# Memorandum

To: Chatham Township Planning Board  
From: Frank Banisch III, PP/AICP  
Date: March 31, 2024  
Re: Mayovska/Dmytryshyn  
Block 54, Lot 16 (5 Mountainview Road)  
Minor Subdivision with variances  
Zone: R-3

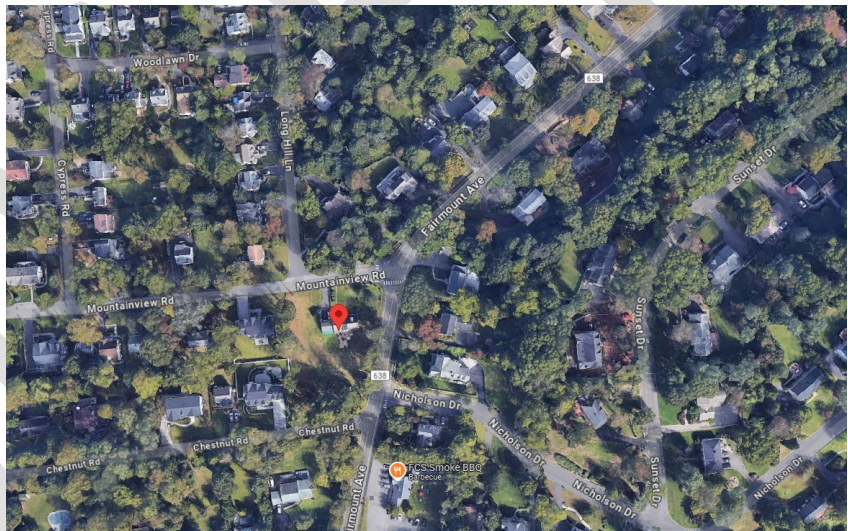
The property is located in the R-3, Residence District, which encompasses most of the more developed southern region of the Township and permits single-family dwellings on a minimum of 20,000 square foot lots (25,000 sf for corner lots). A pocket of the R-4 Residence District, which permits single-family dwellings on 10,000 square foot lots, is located just north of the site. The small lot pattern that pervades this small pocket of R-4 reflects preexisting subdivision and development patterns.

The Township Committee determined in 2019, at the time other lots were rezoned to R-4, that the subject property should be located in the R-3 district, which consists of larger lots along Fairmount Road and beyond, as seen on the Zoning Map excerpt. Thus, it seems clear that when the Township Committee expanded the R-4 zone in the vicinity of Lot 18 in 2019, the dividing line between smaller and larger lots was the basis for the change.
